From: Drew Dara-Abrams <dda@dara-abrams.com>
Sent: Sunday, April 10, 2022 10:37 PM
To: John Knox White; Malia Vella; Tony Daysog; Trish Spencer; Marilyn Ezzy Ashcraft; Xiomara Cisneros; Ronald Curtis; Hanson Hom; Rona Rothenberg; Teresa Ruiz; Asheshh Saheba; Alan Teague; Andrew Thomas
Cc: City Clerk; Nancy McPeak
Subject: [EXTERNAL] feedback on April draft of Housing Element (PB 4/11 Item 7-C and CC 4/19 Item 7-C)

Subject: Draft Housing Element and related zoning text amendments (Item 7-C on 4-11-22 Planning Board agenda)

Subject: Housing Element updates

Housing Element Zoning Amendments - January 28, 2022 Draft

1. WABA Multi Family Overlay Zone proposal 2022-02-04

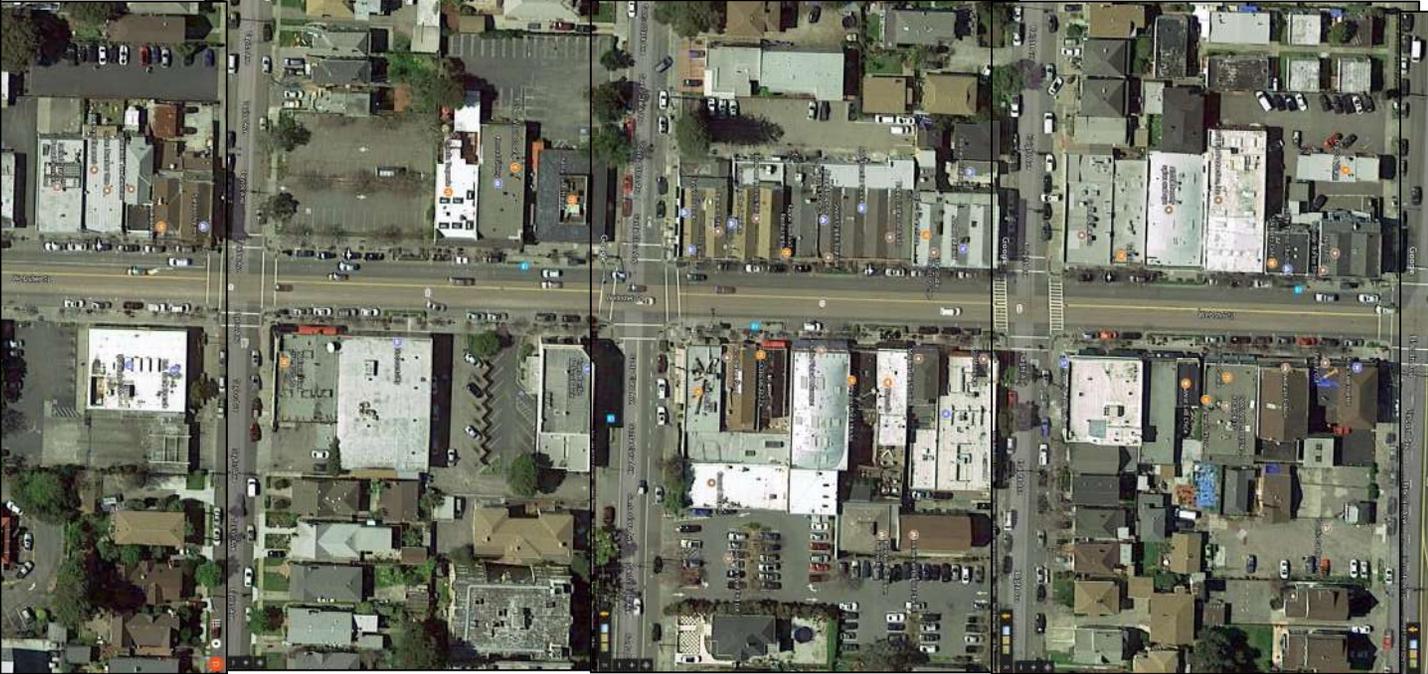
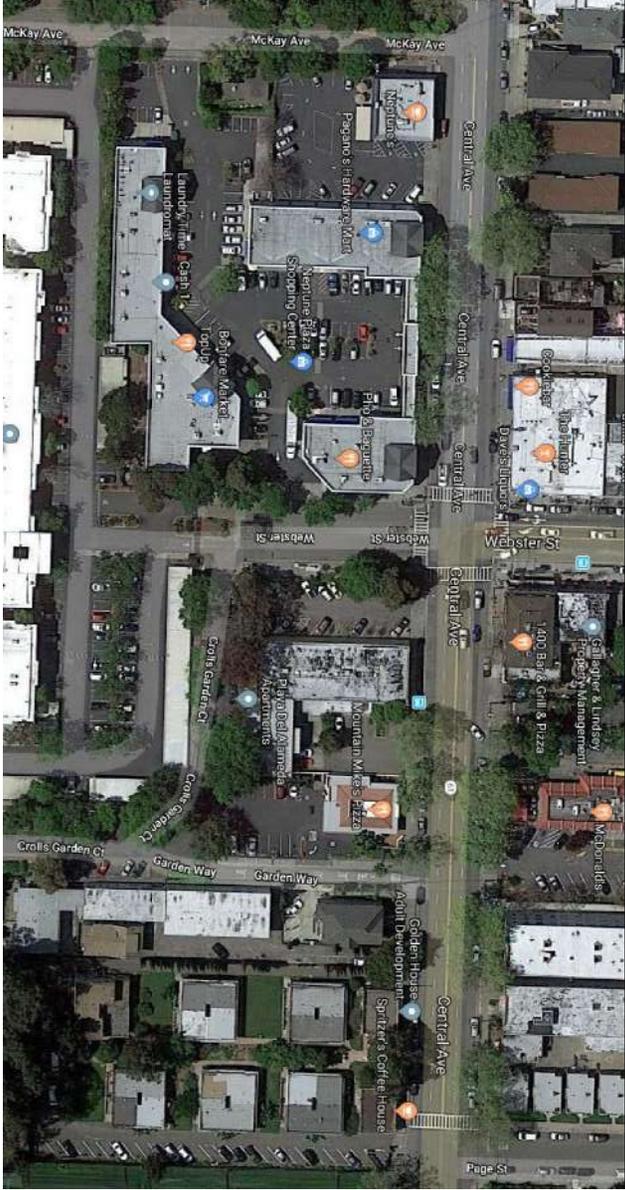
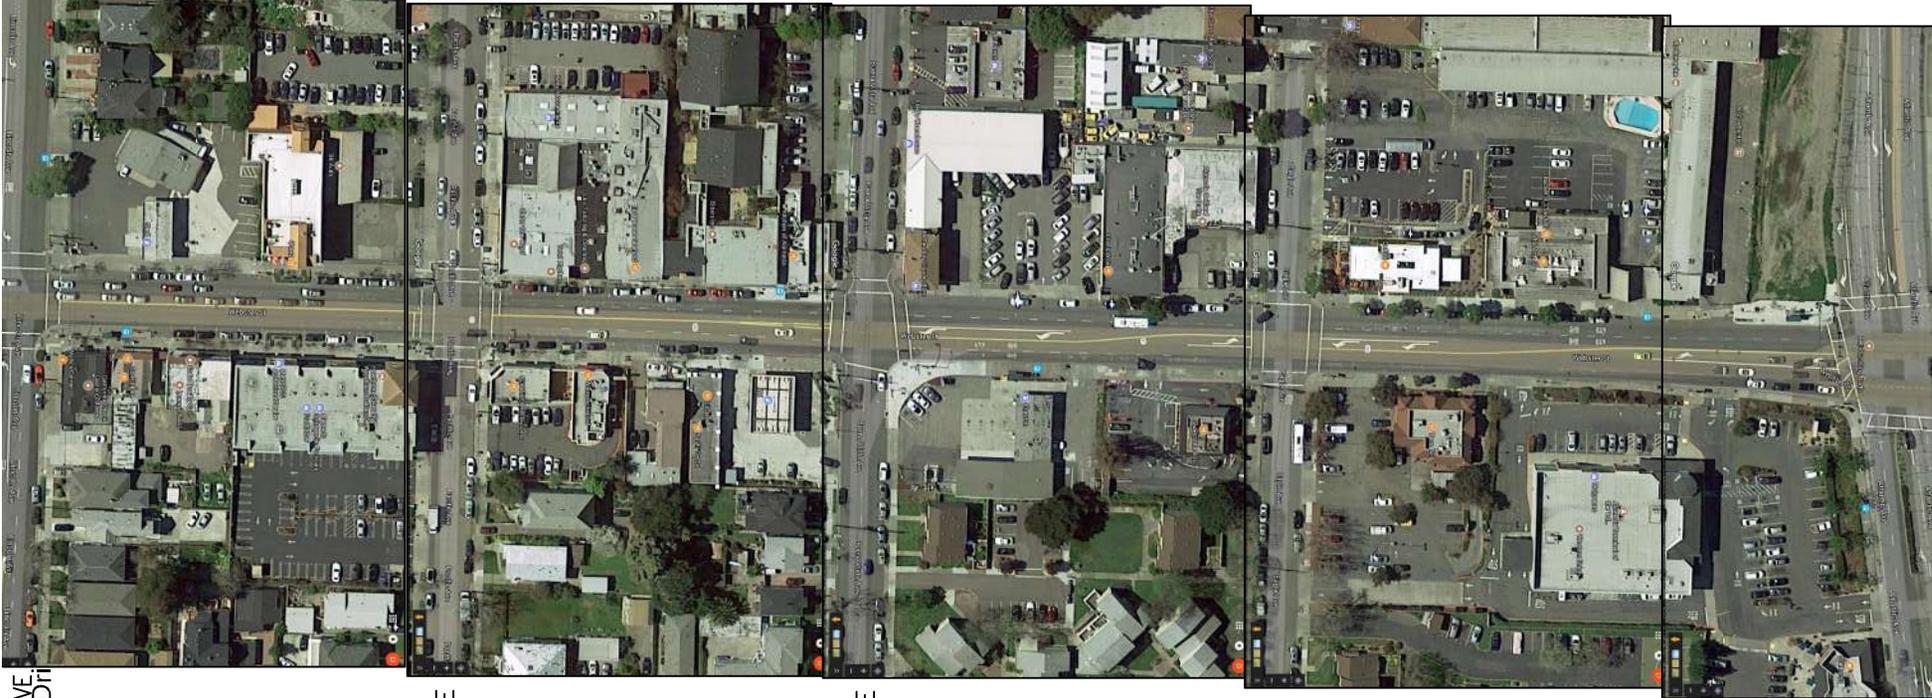
1. NO CHANGES TO NUMBER OF FLOORS ALLOWED
2. INCREASE HEIGHT ALLOWANCE TO 45'
3. MAINTAIN DENSITY LIMIT OF 22 RESIDENTIAL UNITS PER ACRE IF SDBO USED OR USE "FORM BASED CODE" DENSITY (WHATEVER FITS INTO THE BUILDING WITHIN THE ALLOWED HEIGHT), IF NO SDBO USED.
4. REDUCES PARKING REQUIREMENT

1. NUMBER OF FLOORS ALLOWED GRADUALLY INCREASES (CURRENTLY 3 FLOORS)
2. INCREASE HEIGHT ALLOWANCE TO 45' (CURRENTLY 40') THEN GRADUALLY INCREASES HEIGHT PER DIAGRAM.
3. MAINTAIN DENSITY LIMIT OF 22 RESIDENTIAL UNITS PER ACRE IF SDBO USED OR USE "FORM BASED CODE" DENSITY (WHATEVER FITS INTO THE BUILDING WITHIN THE ALLOWED HEIGHT), IF NO SDBO USED.
4. REDUCES PARKING REQUIREMENT

45' HT ALLOWED @ STREET FRONT WITH 3 FLOORS
 55' HT ALLOWED @ SIGHT LINE SETBACK WITH 4TH FLOOR

- 55' HT ALLOWED @ STREET FRONT WITH 4 FLOORS

- 55' HT ALLOWED @ STREET FRONT WITH 4 FLOORS
- 65-70' HT ALLOWED @ SIGHT LINE SETBACK WITH 5 FLOORS

- 55' HT ALLOWED @ STREET FRONT WITH 4 FLOORS
- 65-70' HT ALLOWED @ SIGHT LINE SETBACK WITH 5 FLOORS
- ±77' HT ALLOWED @ SIGHT LINE SETBACK WITH 6TH FLOOR

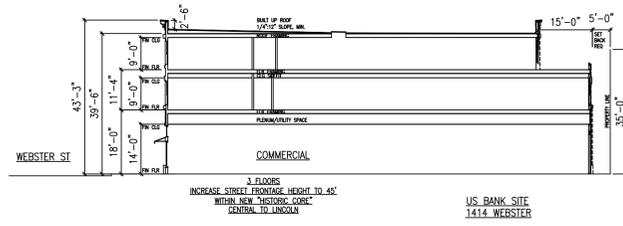
Webster Street District—Maximum height shall be ~~as follows: three (3) stories but not to exceed forty (40') feet throughout the C-C District~~

- Properties fronting onto the south side of Central Avenue - fifty five (55') feet, provided that any portion of the building that exceeds forty five (45') feet is set back at least ten (10') feet from the face of the building.
- Properties fronting onto Webster Street between Central Avenue and Lincoln Avenue, and properties fronting onto the north side of Central and south side of Lincoln - forty five (45') feet;
- Properties fronting onto Webster Street between Lincoln Avenue and Pacific Avenue and properties fronting onto the north side of Lincoln and the south side of Pacific - fifty five (55') feet, provided that any portion of the building that exceeds forty five (45') feet is set back at least ~~ten (10')~~ ten (10') feet from the face of the building; *(@ both front + rear PL)*

24°

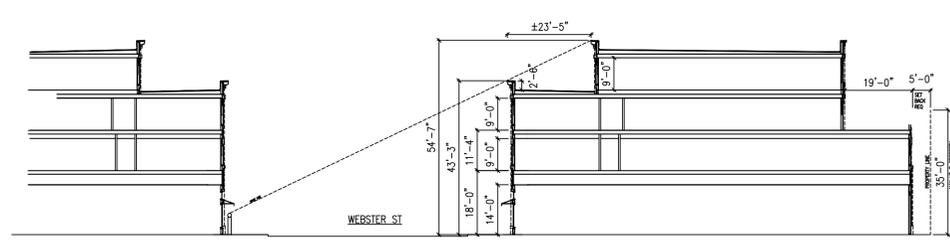
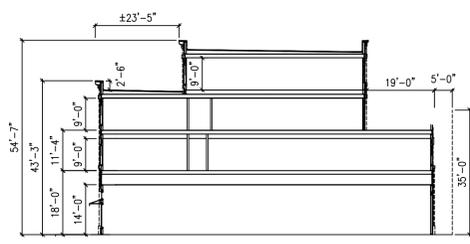
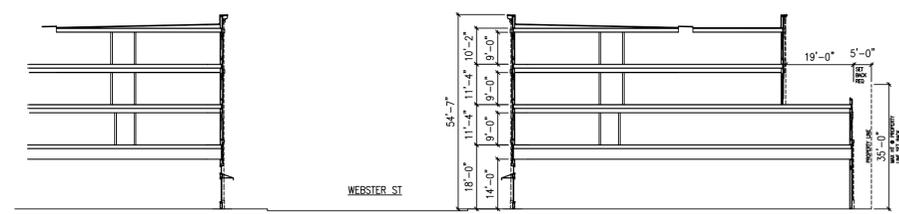
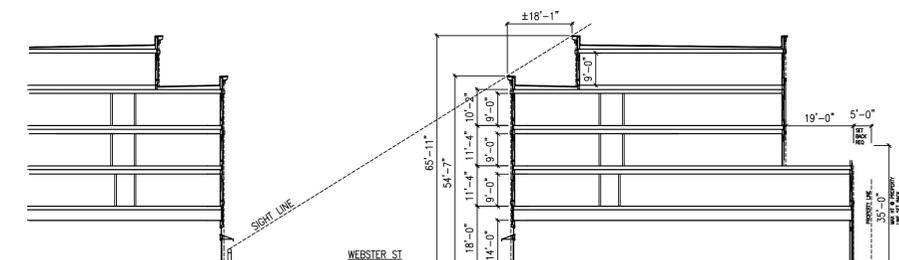
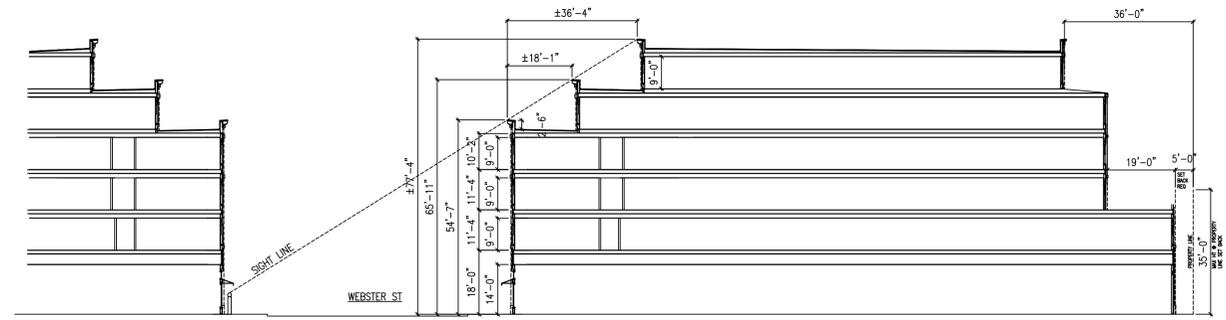
3 FLOORS + 4TH FLOOR AT REAR OF BUILDING
WEBSTER FROM LINCOLN TO FINCH
INCREASE HEIGHTS TO 45' AT STREET FRONT
55' AT 4TH FLOOR

4 FLOORS
WEBSTER FROM FINCH TO BUENA VISTA
55' HEIGHT LIMIT

4 FLOORS + 5TH FLOOR AT REAR OF BUILDING
WEBSTER FROM BUENA VISTA TO EAGLE
INCREASE HEIGHTS TO 55' AT STREET FRONT
45' AT 5TH FLOOR

4 FLOORS + 5TH & 6TH FLOOR AT REAR OF BUILDING
WEBSTER FROM EAGLE TO ATLANTIC
45' HEIGHT LIMIT AT STREET FRONT
47.7' AT 6TH FLOOR

2022-01-31
match rear setbacks to
duplicate front setbacks
